SUBJECT: CATAWBA NUCLEAR STATION, UNITS 1 AND 2 – STAFF ASSESSMENT OF FLOODING FOCUSED EVALUATION (EPID NO. L-2018-JLD-0178)

STAFF ASSESSMENT BY THE OFFICE OF NUCLEAR REACTOR REGULATION

CATAWBA NUCLEAR STATION, UNITS 1 AND 2

RECOMMENDATION 2.1 - FLOODING

Figure 1 - Catawba Nuclear Station site layout with key locations for monitoring flood elevations, where the Catawba Intake is the point of interest for the site inundation analysis (Source: Catawba MSA with NRC notations added).

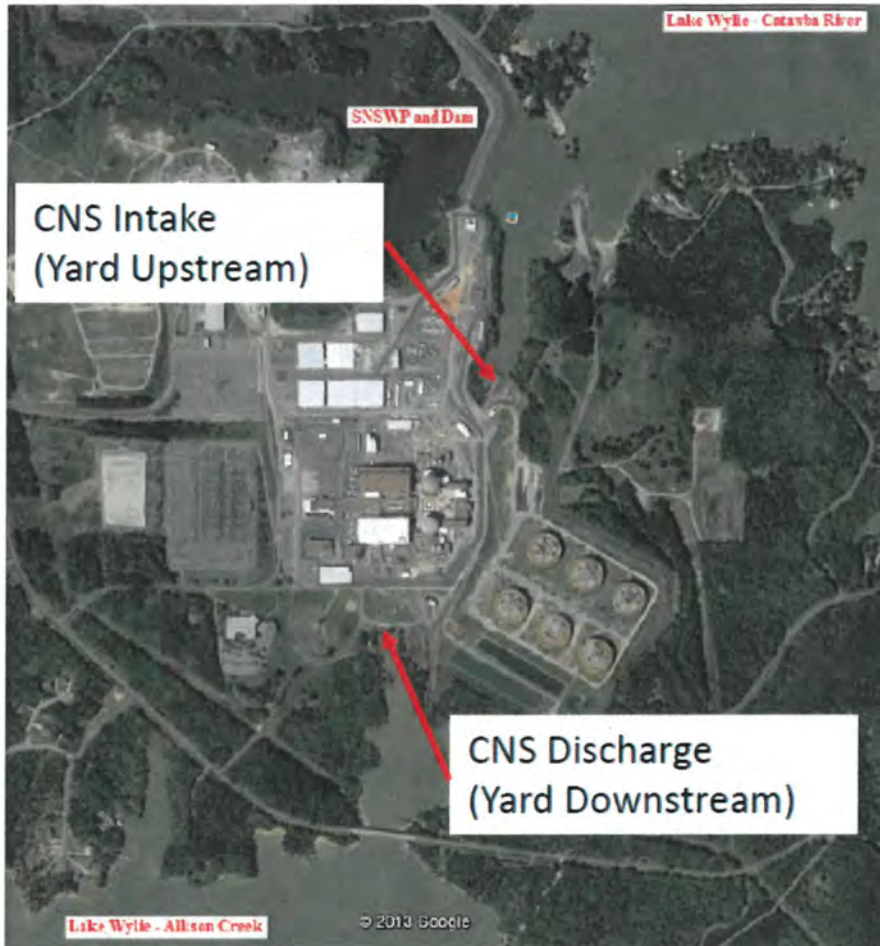
(CEII) The licensee reported in the MSA that the refined maximum flood elevation with wind-driven wave runup for the combined dam failures event is [[ ]] at the Catawba intake structure, which is the point of interest for the site inundation analysis (see Figure 1).

Figure 2 - Spatial distribution patterns of the NRC staff's ssPMPs for five selected storms used to simulate HEC-HMS.

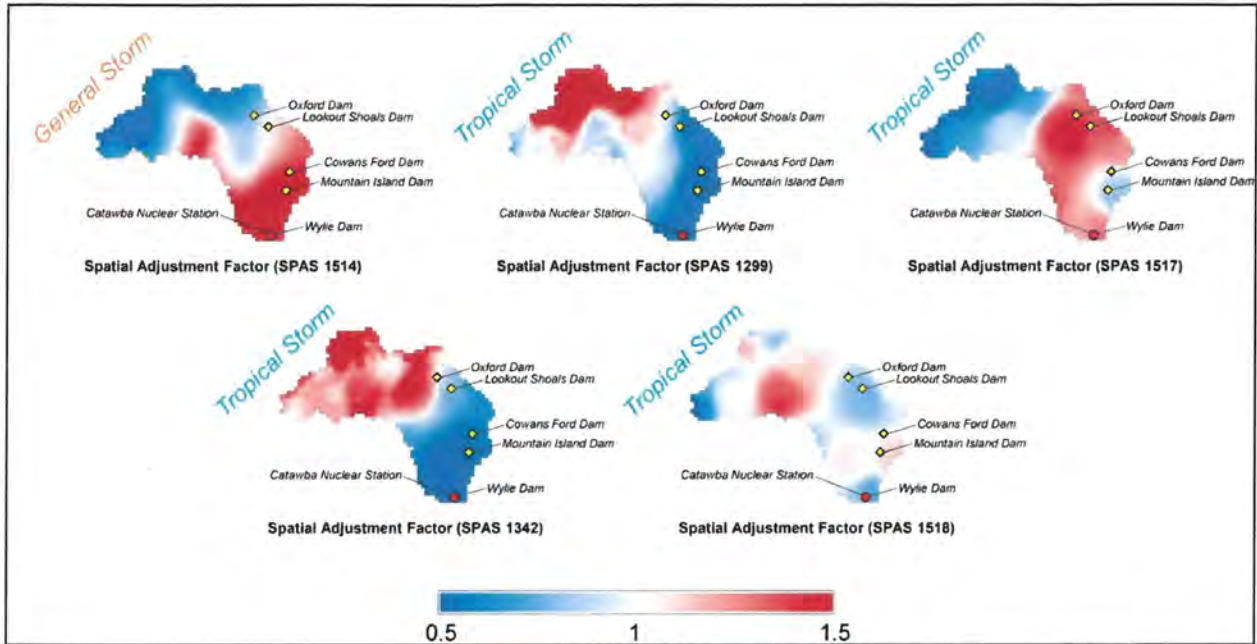
- The NRC staff examined the variability of the NRC staff-estimated ssPMP values by subbasin for the five licensee-selected storms (see Figure 2). As a result, the NRC staff

found the five selected storms provide sufficient spatial variability in all subbasins. The NRC staff also plotted, for each storm, the pattern of spatial adjustment factors that are representative of the observed rainfall as it fell spatially within the basin but does not align with the theoretical PMP pattern (see Figure 2). From these maps, the NRC staff confirmed that the spatial patterns used by the licensee represent sufficiently diverse storm centers: two upstream, two downstream, and one midstream.
